**Sent:** 1/07/2020 10:44:55 AM  
**Subject:** DA2020/0586 - 4 Laura Street, Seaforth  
**Attachments:** 4 Laura Street, Seaforth (Objection) .pdf;

**4 Laura Street, Seaforth**  
**Development Application No DA2020/0586**  
**Proposed alterations and additions to an existing dwelling house**

Figure 1. Extract from DA198/2010 showing approved eastern elevation

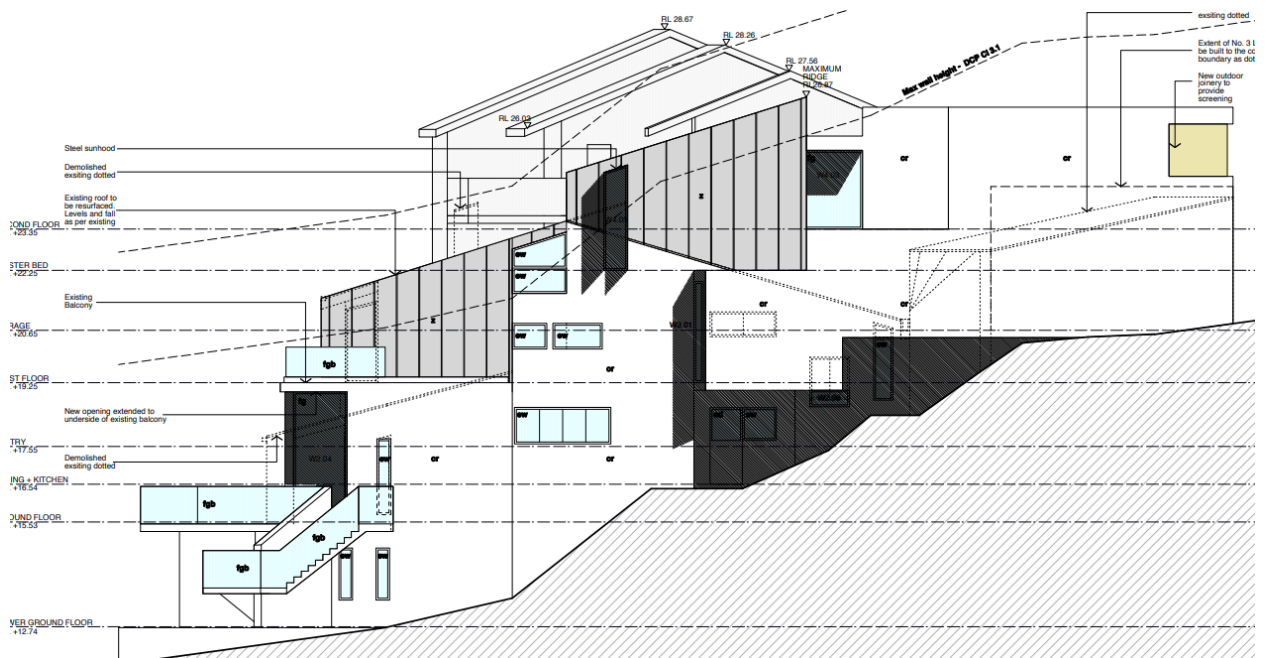
The original Development Consent for alterations and additions to the dwelling at 4 Laura Street, Seaforth, was approved by Council in 2010 (DA198/2010). A review of these plans reveals that the “balcony” referred to in this current Development Application was actually approved as roof space. See Figure 1 below with an extract of the approved eastern elevation, with no door or balustrade shown.

An accurate description of the proposed works would be a change of use of the existing roof top to a balcony.

Figure 1. Extract from DA198/2010 showing approved roof top area with window (no door access to roof top and no balustrade)

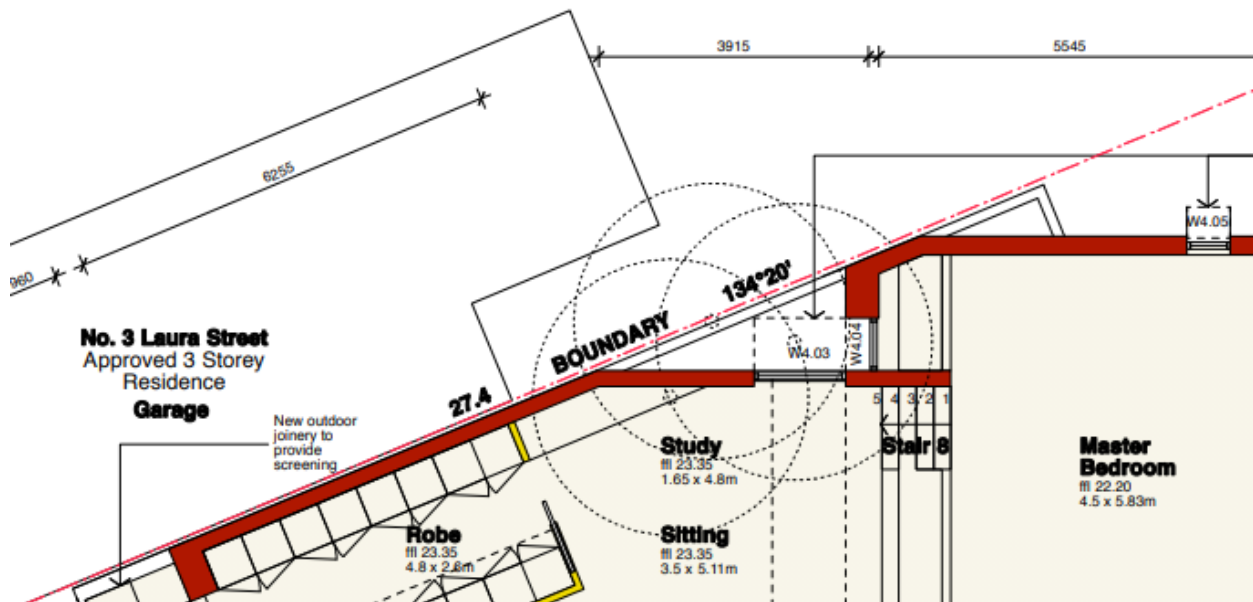
Also see figure 2, below, which shows an extract of the relevant area of the approved floor plan of the upper level of the building with windows provided to the eastern elevation and no physical access to the roof top space adjacent 3 Laura Street on the eastern boundary.

Additionally, we note that a door appears to have been constructed in the place of approved window 4 without consent. This door is unauthorised works and should be removed.

Additionally, the owners should be issued a notice of intention to issue an order to remove the door which as been constructed in place of approved window 4. This is an unauthorised use and highly inappropriate in this location.
